PETERSEN POINTE SUBDIVISION

APPLICATION NUMBER 17 DATE June 7, 2007

DETAIL SITE PLAN

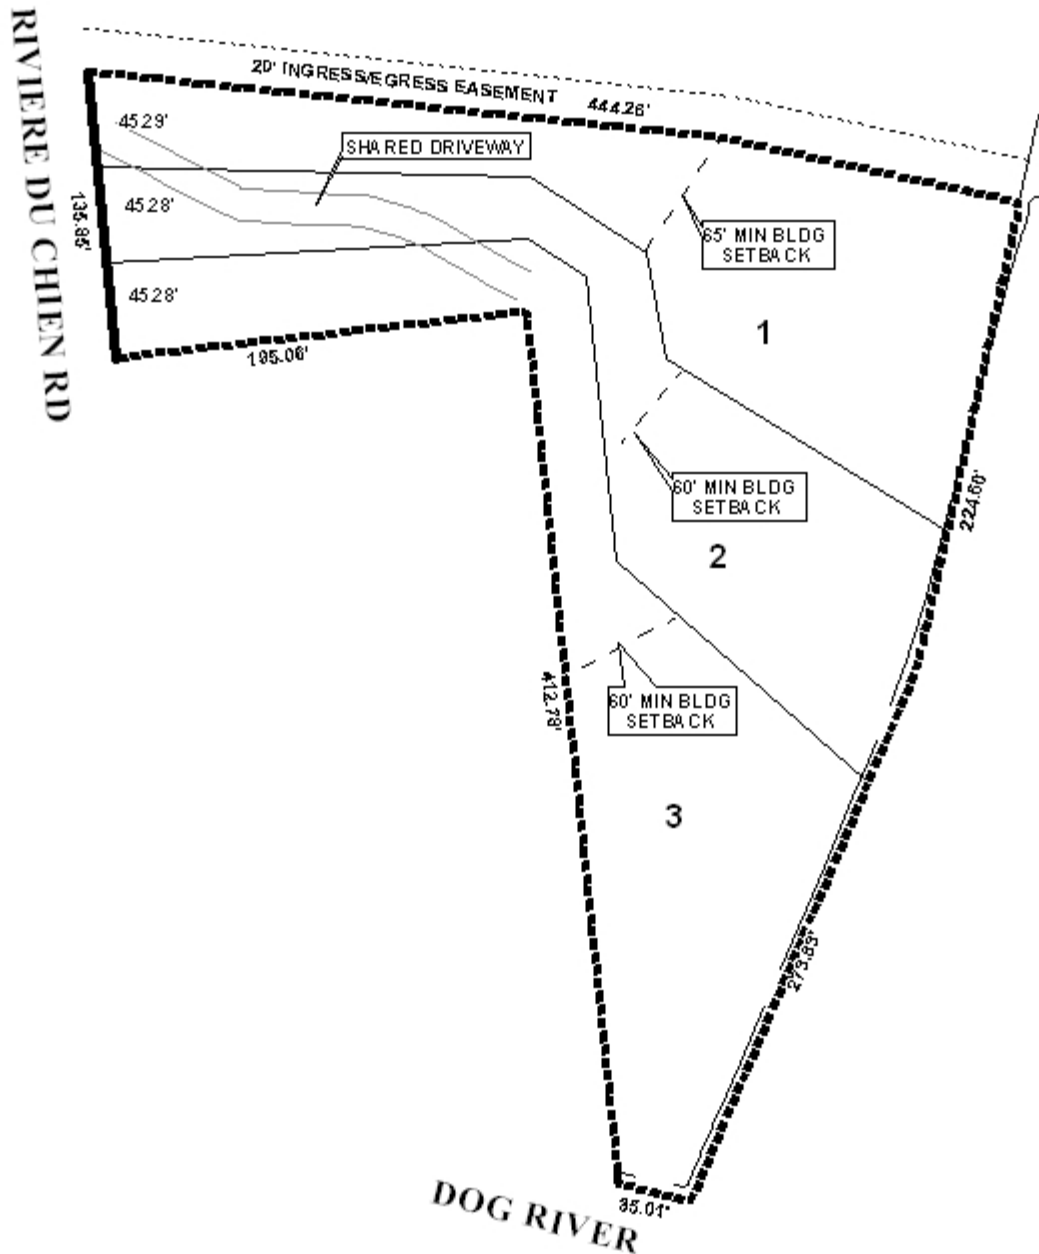
The plat illustrates the proposed 2.2± acres, three lot subdivision, which is located on the East side of the South terminus of Riviere du Chien Road, in city council district 4. The subdivision is served by city water and sanitary facilities.

The plat illustrates one common driveway to access all three proposed lots. The size, location, and design of the common driveway (and any for individual lots) should be coordinated with and approved by Traffic Engineering and conform to AASHTO standards. Referenced in the property's legal description and illustrated on the plat is a 20' ingress and egress easement jointly shared by the subject property and the adjacent property to the North. Since that property is not included in this application and the easement is not intended to serve the subdivision, it cannot be made part of the subdivision's approval and should be excluded from the legal description placed on the final plat.

As the site is located on Dog River, the area is in a flood plain and may be environmentally sensitive; therefore, the Engineering Comments would apply.

The Northern portion of the property has water frontage along a privately dredged canal and concerns were expressed by the owner of the canal regarding the denial of access from the subdivision to the

canal. While the property boundary between that portion of the subdivision and the private canal may be along the East line of a portion of the subdivision, matters pertaining to the canal's limited access would be a Corps of Engineers or civil matter and would not factor into the subdivision application review or approval.

1. the size, location, and design of the common driveway (and any for individual lots) be approved by Traffic Engineering and conform to AASHTO standards;

2. the removal in the legal description of any reference to the 20' joint driveway currently shared with the adjacent property to the North, and the removal of any depiction of the easement on the final plat; and

3. subject to the Engineering Comments (Show the minimum finished floor elevation, on each lot touched by 100 or 500-year flood plain. No fill allowed in the flood plain without a flood study. Provide adequate drainage easement, if necessary. It is the responsibility of the applicant to look up the site in the City of Mobile (COM) GIS system and verify if NWI wetlands are depicted on the site. If the COM GIS shows wetlands on the site, it is the responsibility of the applicant to confirm or deny the existence of wetlands on-site. If wetlands are present, they should be depicted on plans and/or plat, and no work/disturbance can be performed without a permit from the Corps of Engineers. Must comply with all storm water and flood control ordinances. Any work performed in the right of way will require a right of way permit.)
